September 6, 2024  
240199

**Review Services for the “Island Rover,” Temporary Access and Boat Launch at “0” Shore Drive, Freeport, Maine**

Re: Carter Becker, Shore Drive (Map 5, Lot 96A)- Response to Sebago Technics Report

REV. BY: RAC DATE: 05/12/24  
DESCRIPTION: PROFILE

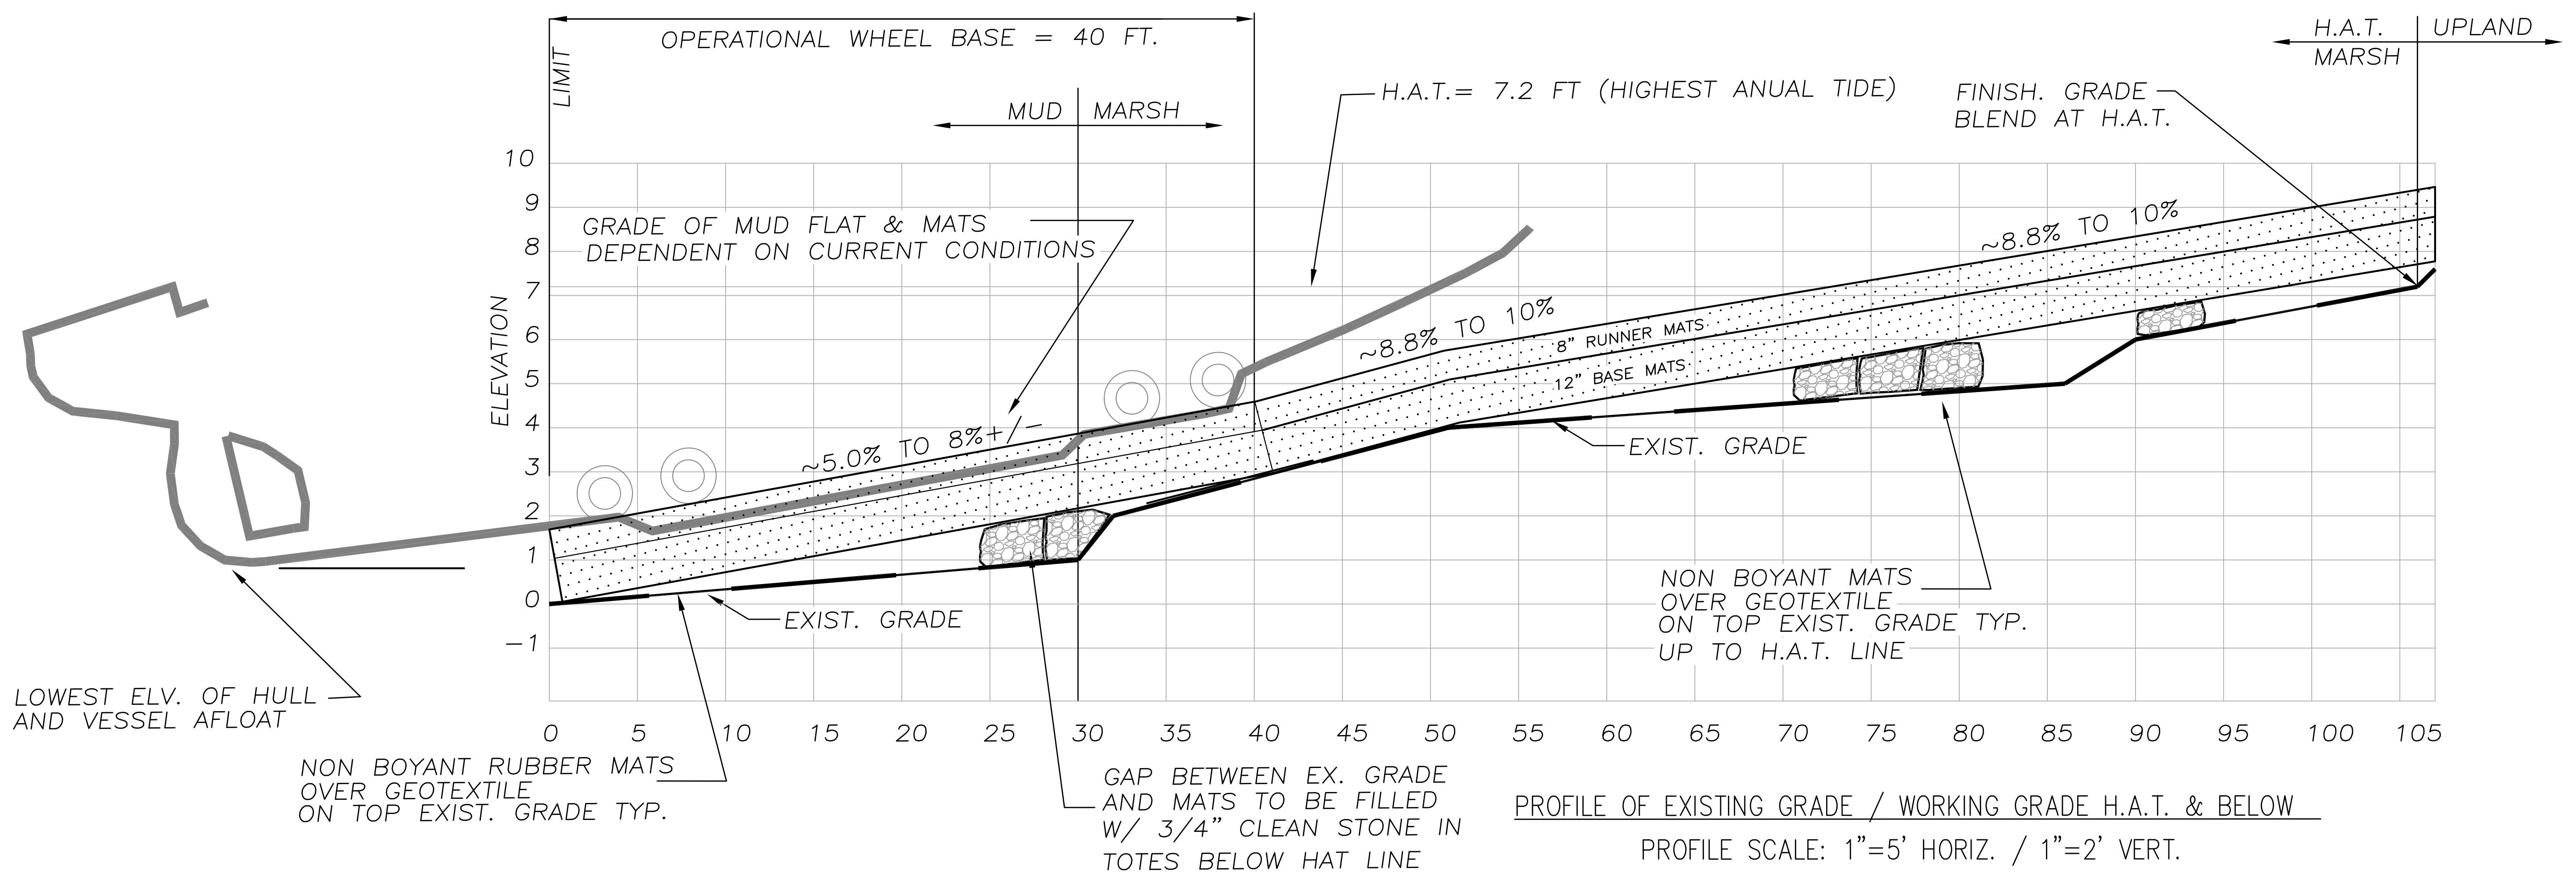
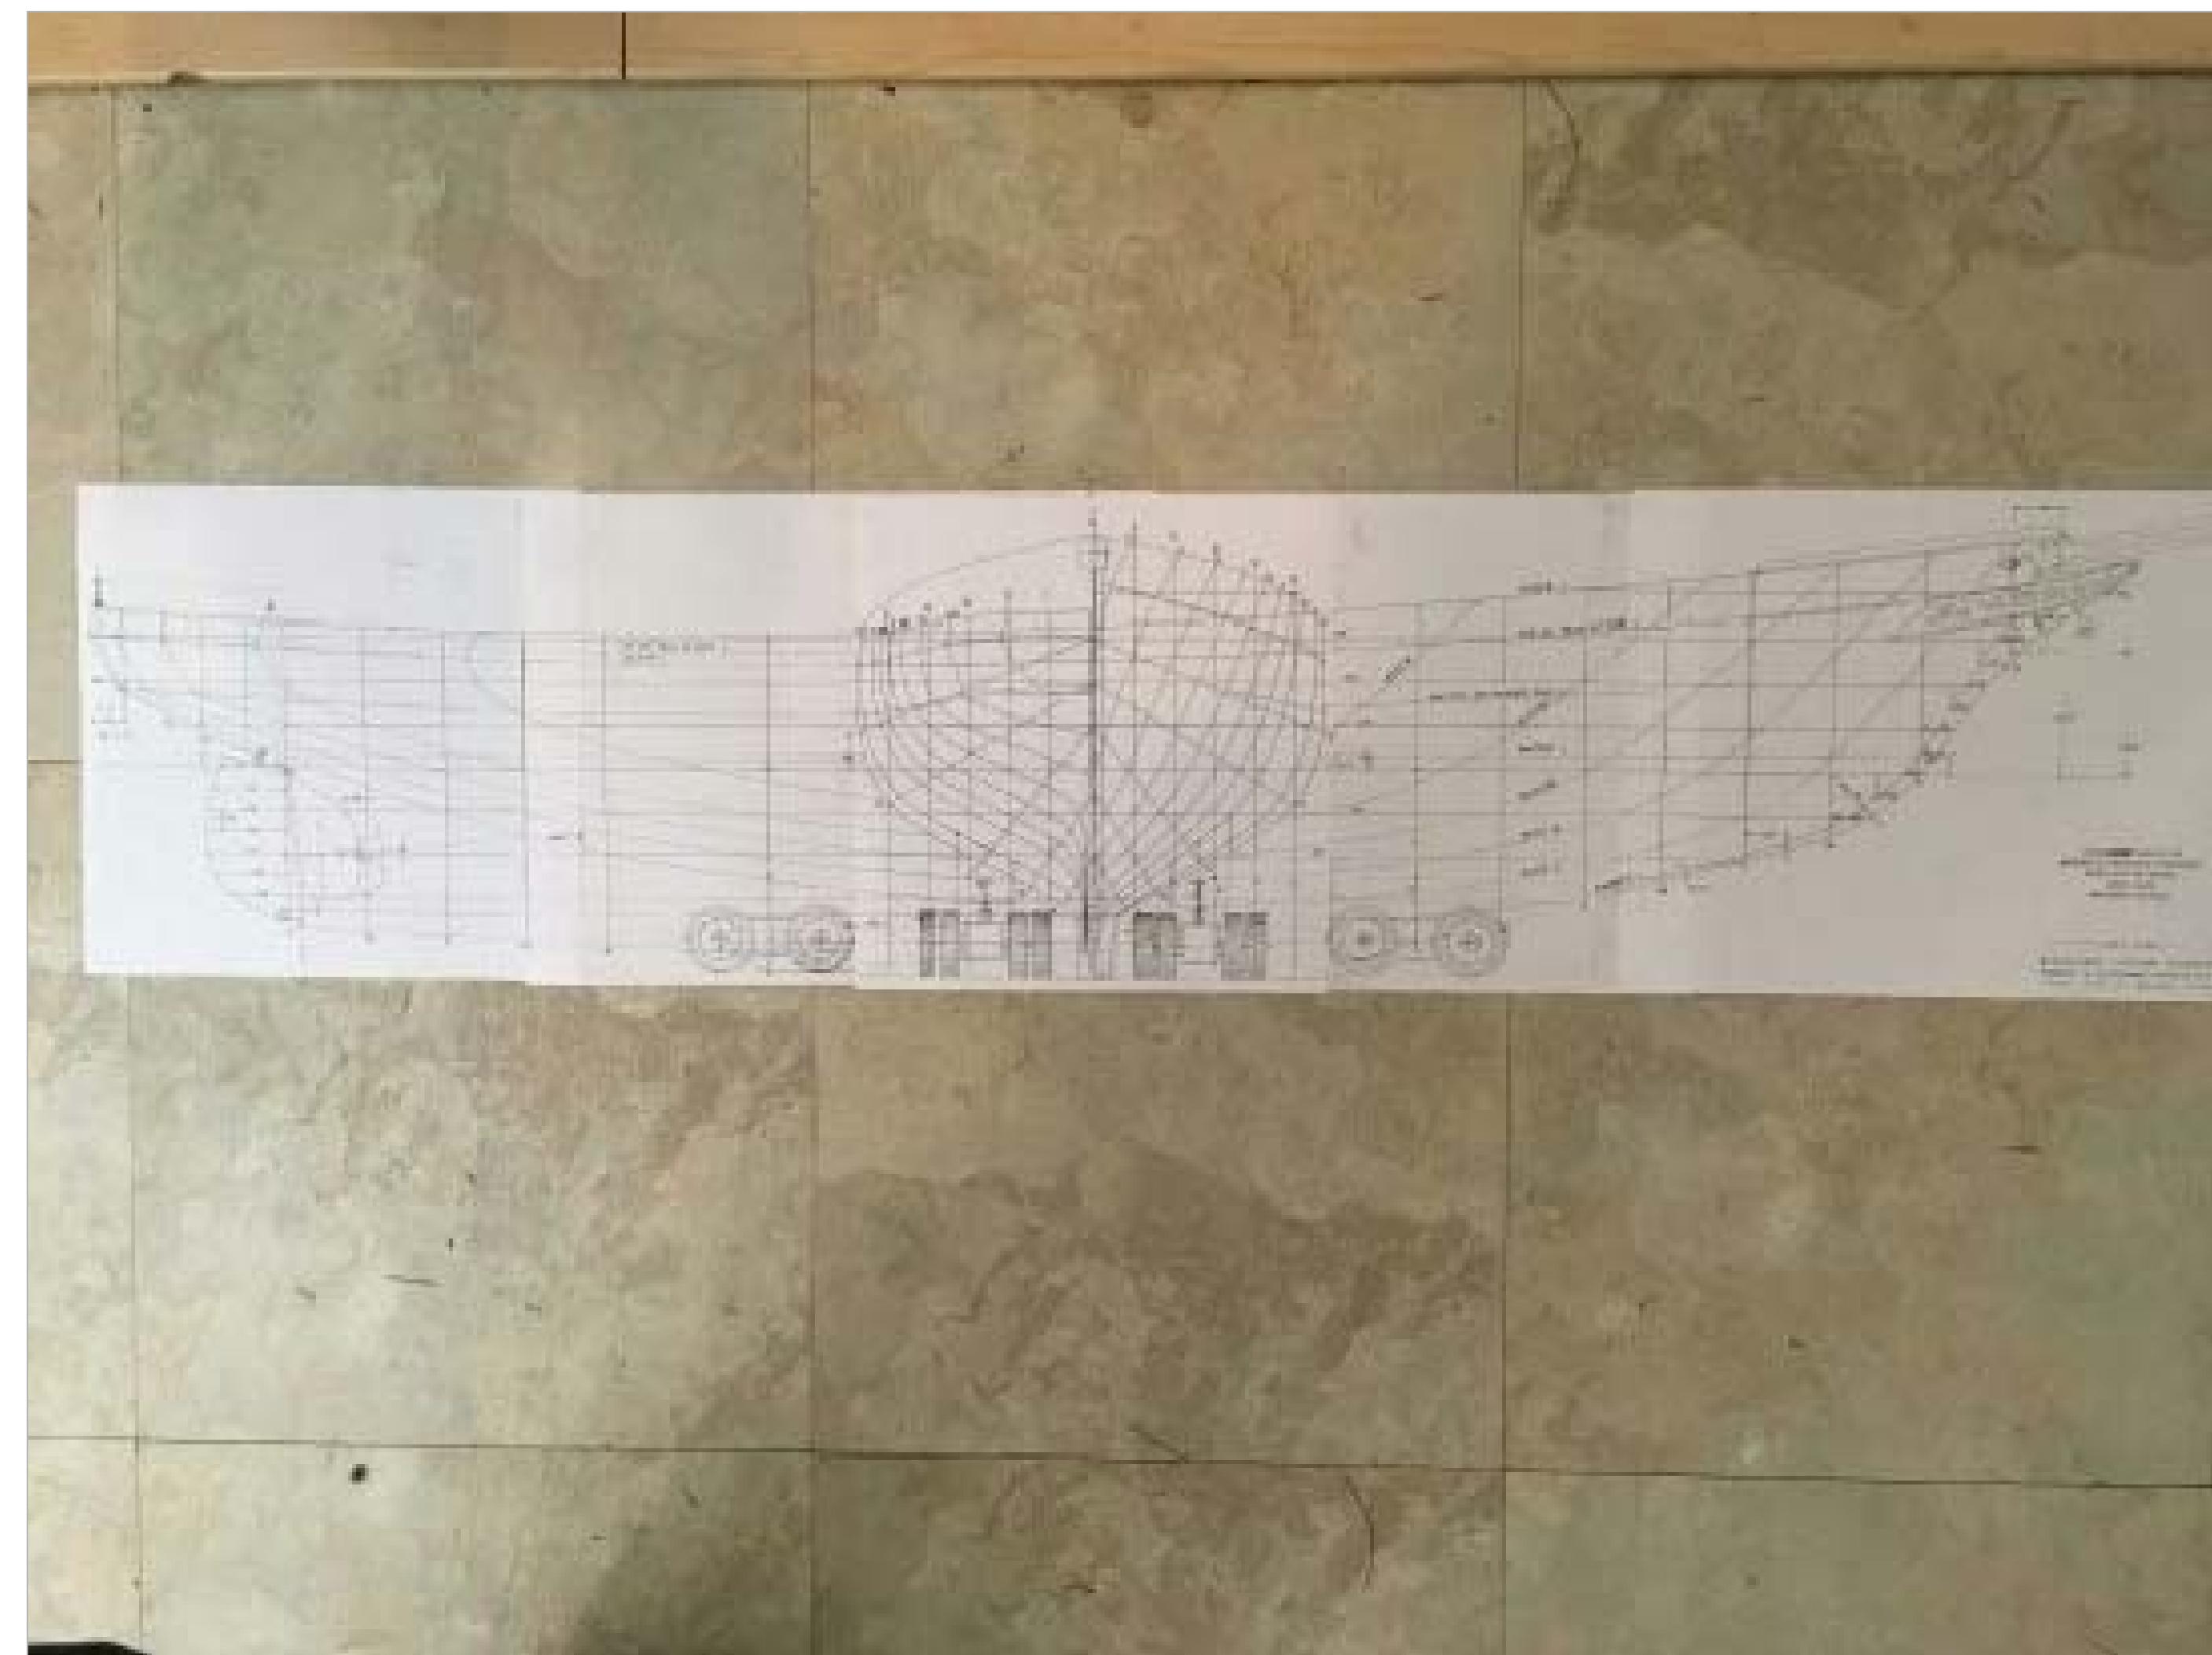
We recommend the applicant prepare a scaled profile of the access road including existing contour elevations, proposed top of crane mats, limits of the coastal vegetation, profile of the Island Rover at the launch point, mud flat, and waterline profile noting mean high water, observed tide elevation, the limit of crane mats and extended profile beyond the end of the crane mats to assess depth for floating the ship. The scaled profile will be helpful to better understand the relationship between the existing soils, crane mat buildup, and water available for the flotation of the ship. We would note that the crane mat buildup shown on the site plan suggests approximately 2' of sectional buildup but the finish contours at the 40-foot section of 5% grade depict approximately 1 foot from the top of the mat to the existing ground surface.

4. We understand the Island Rover to be approximately 113 feet long (overall length). The site plan depicts a 40-foot-long (5%) launch pad at elevation 1-2. The applicant should provide documentation noting that the 40-foot-long (5% launch pad grade) is adequate given the length and profile of the ship bottom. We also suggest the profile of the ship be drawn to scale on the profile requested in item 2 above along with the locations of the floatation bags, and the vessel carrying system.

*Supplemental Comments: The applicant has provided a scaled plan as requested which addresses our comments for the profile. The applicant has responded that the flotation comments fall outside the purview of the Coastal Waters Commission. We would defer to the town's legal counsel for jurisdictional determinations.*

*Supplemental Comments:* *The applicant has provided a profile with explanation that addresses our initial review comment. The applicant has responded that the floatation comments fall outside the purview of the Coastal Waters Commission which is a jurisdictional question for the Coastal Waters Commission legal counsel.*

2. The Reviewer requests a scaled profile of the access road as it may be helpful to understand, in part, the water available for the floatation of the vessel. A scaled profile plan is provided and attached to this response. The profile plan provides a

4. The Reviewer requests that the applicant provide the vessel profile and vessel carrying system on the profile plan requested in #2, above. This has been included in the attached profile plan. The profile plan demonstrates that the 40' long project terminus is sufficiently sized for the vessel and its carrying system components. Plans depicting the locations of floatation bags have been provided to the Commission previously, although the floatation system design again is not within the Commission's scope of review.
5. The Reviewer recommends that a geotechnical engineer review the site conditions and the calculations that have been provided by the design engineer. The project was designed by a Licensed Professional Engineer according to accepted engineering
